HISTORIC PRESERVATION COMMISSION

SUBJECT: Historic Area Work Permit #454391, Tree removal and replacement

MONTGOMERY COUNTY HISTORIC PRESERVATION COMMISSION
STAFF REPORT

Address:	15 West Lenox Street, Chevy Chase	Meeting Date:	06/13/07
Resource:	Contributing Resource Chevy Chase Village Historic District	Report Date:	06/06/07
Applicant:	Mr. and Mrs. Lee Jundanian (Nicole Whiteside, Landscape Architect)	Public Notice:	05/30/07
Review:	HAWP	Tax Credit:	None
Case Number:	35/15-07V	Staff:	Anne Fothergill
PROPOSAL:	Tree removal and replacement

Sheet #	Title	
TR 1	Existing Conditions	
Date	Scale	
April 30, 2007	1/32" = 1'-0"

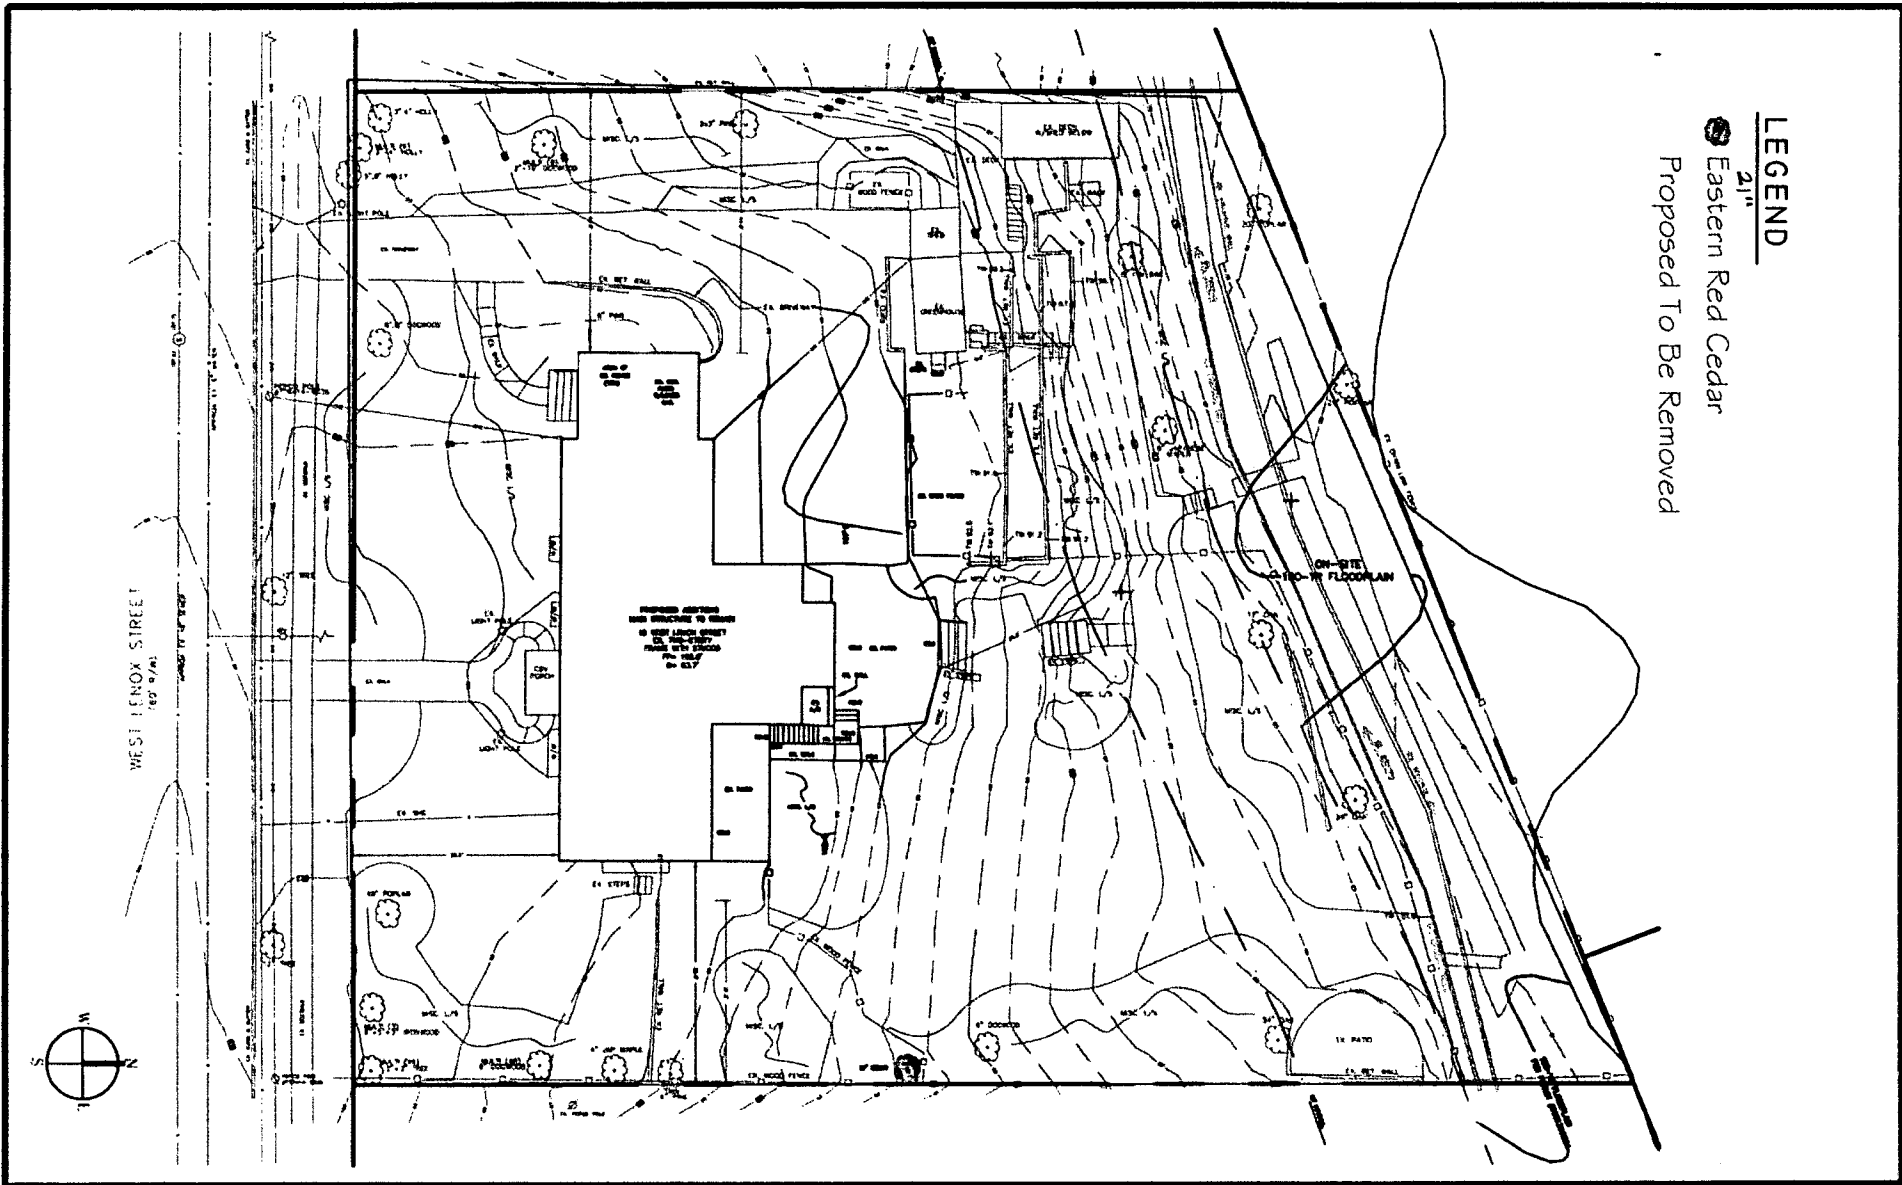
The applicants propose to remove one 21” cedar tree located along the east property line behind the house that is in poor health according to the arborist’s report. They will plant replacement trees including three evergreen trees, one specimen tree, and one canopy tree. The Village has approved the tree removal and replacement as complying with the Village Urban Forest Ordinance.

The applicants are proposing to plant more trees than they are removing. Chevy Chase Village has an Urban Forest Ordinance and the proposed tree removal and replacement was reviewed and approved by the Village Board. Staff is recommending approval.

Staff recommends that the Commission **approve** the HAWP application as being consistent with Chapter 24A-8(b)(1) & (2);

Title	Site Plan
	Date
Scale	1/32" = 1'-0"
	Date
April 30, 2007

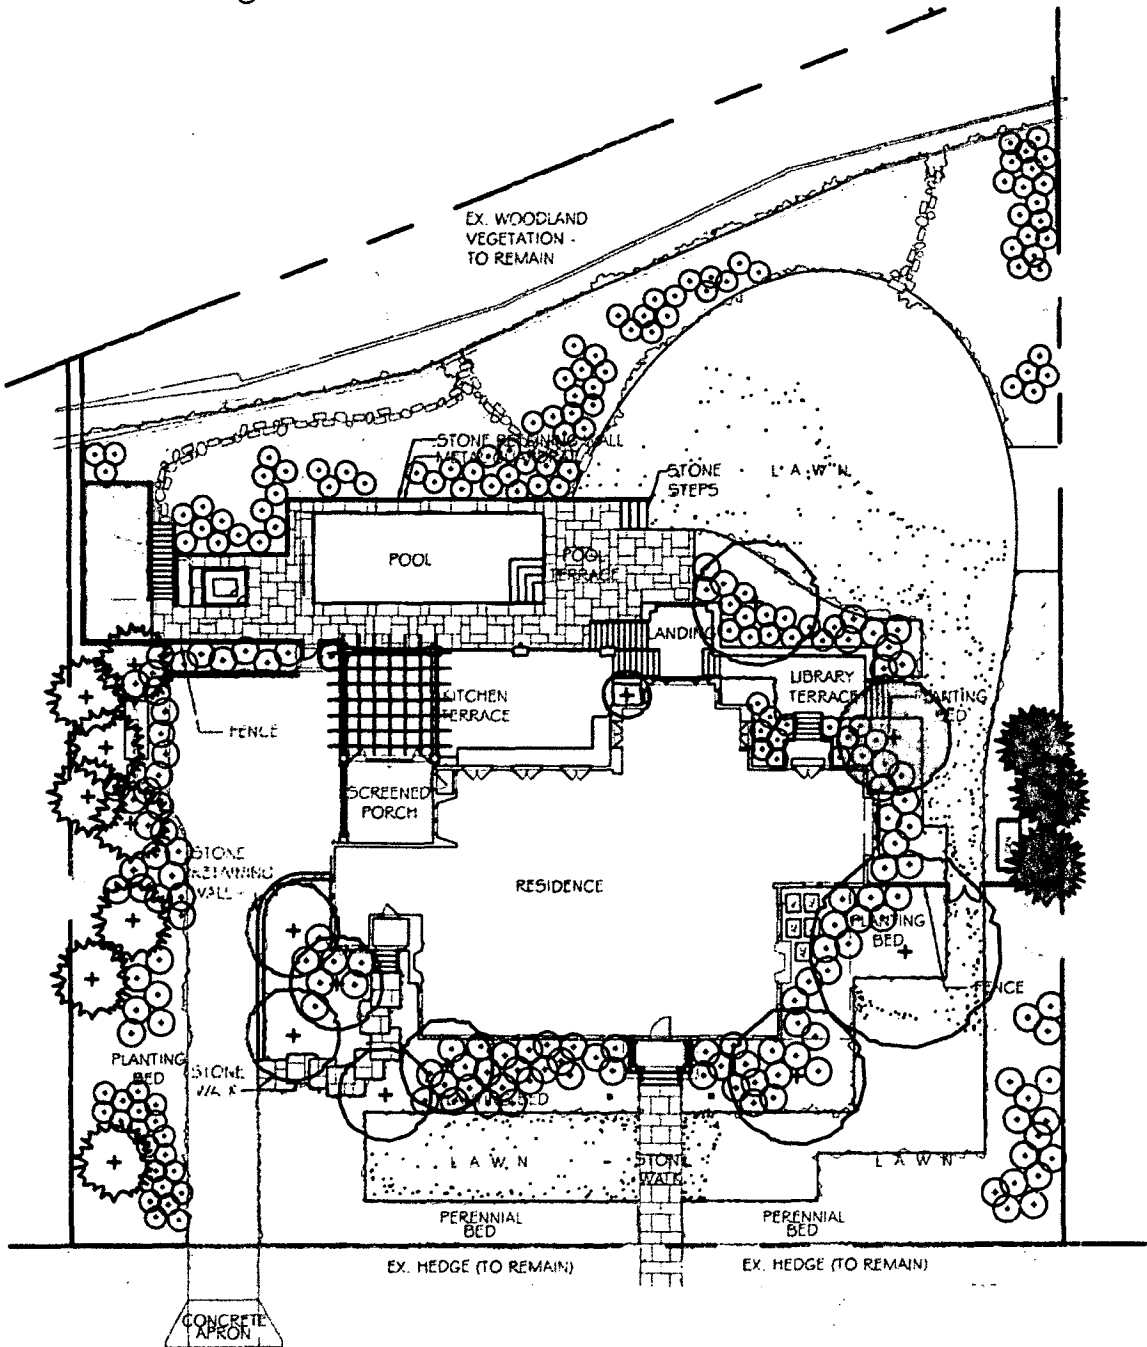
Trees in green (3 *Cryptomeria japonica* 'Yoshino' and 1 *Stewartia pseudocamellia*) represent the replacement trees for the cedar that is proposed to be removed.
